# Technical Service Bulletin

## 19 Heating output insufficient

19 17 78 2046971/1 February 24, 2017.

Model(s)	Year	VIN Range	Vehicle-Specific Equipment
S8 +	2016 - 2017	All	Not Applicable

Figure 1. Hose with check valve.

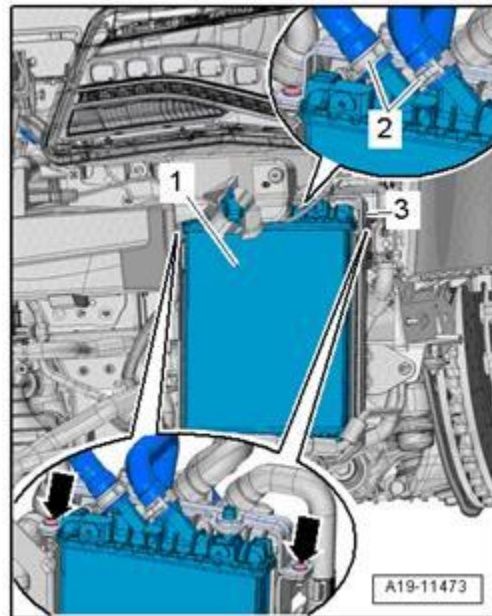
Improved lower coolant hose with check valve.

4. Replace hose with check valve.
